PERMIT
CITY OF NAPOLEON - BUILDING DEPARTMENT

Job Location 1130 Hurst Drive
address

Re: The List of Items Which You Were
to Furnish.

DATE _____ WALL SECTION @ CRAWL SPACE DWG. NO OF _____

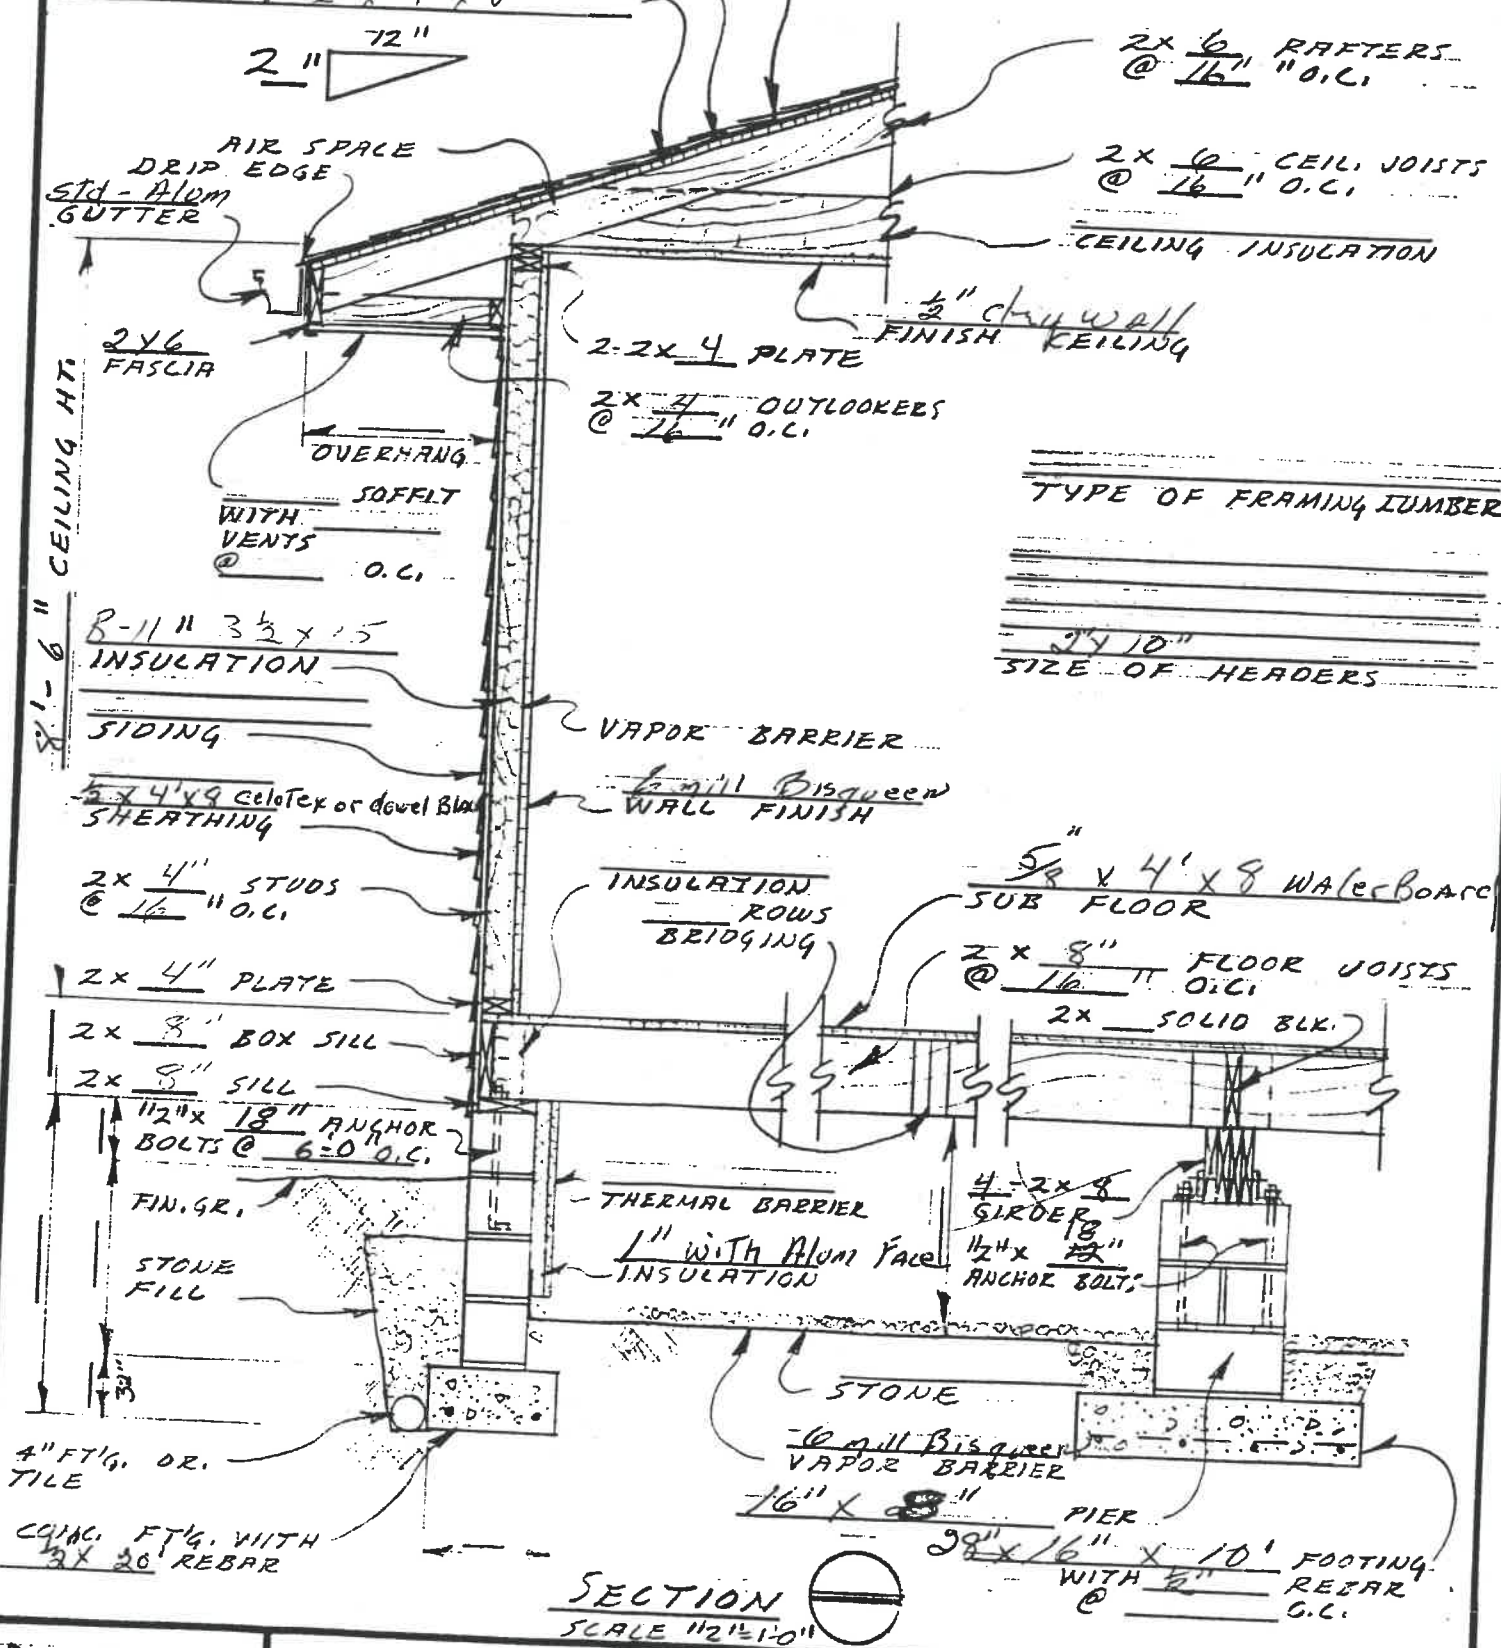
- OK* 1 Plumbing Isometric.
- OK* 2 Window sizes from your information. I cannot determine what type of window (casement, hopper vent, double hung, etc.) also which window is a W-2 and a W-3 marked on your floor plan.
- 3 Confirming our phone conversation this morning a 6 X 6 wood beam will not support the roof and ceiling over the bedroom and kitchen openings. Please consult with your builder and have the size of this beam increased to support the loads over these openings which are approximately 12' to 13' wide.

Since the opening dimensions are not listed on your floor plan, they should be listed on your design information.

Some alternatives you may wish to consider are laminated wood beams and steel beams.
